In the Drawings:

In compliance with the Examiner's requirements, Applicant submits herewith a set of formal drawings which incorporate all proposed amendments in the last response filed at the patent office.

FIG. 4

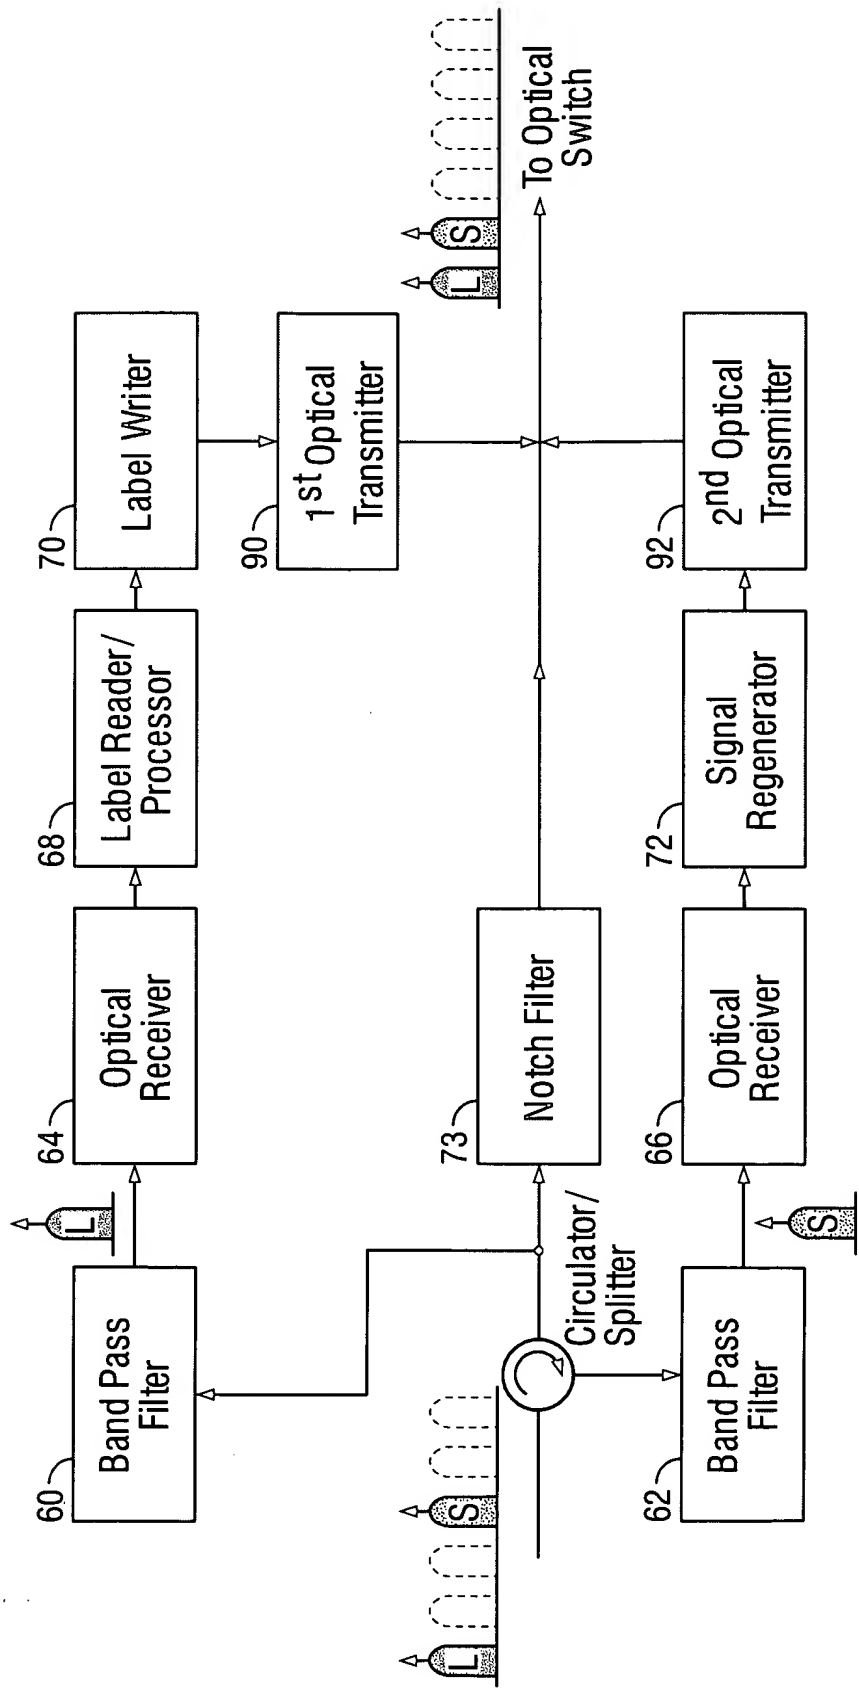
In addition, FIG. 4 has been further amended to remove an extra arrowed line in the spectrum of the output signal. This change simply conforms FIG. 4 to the textual description on page 13, lines 11-16 of the original specification. No new matter is added.
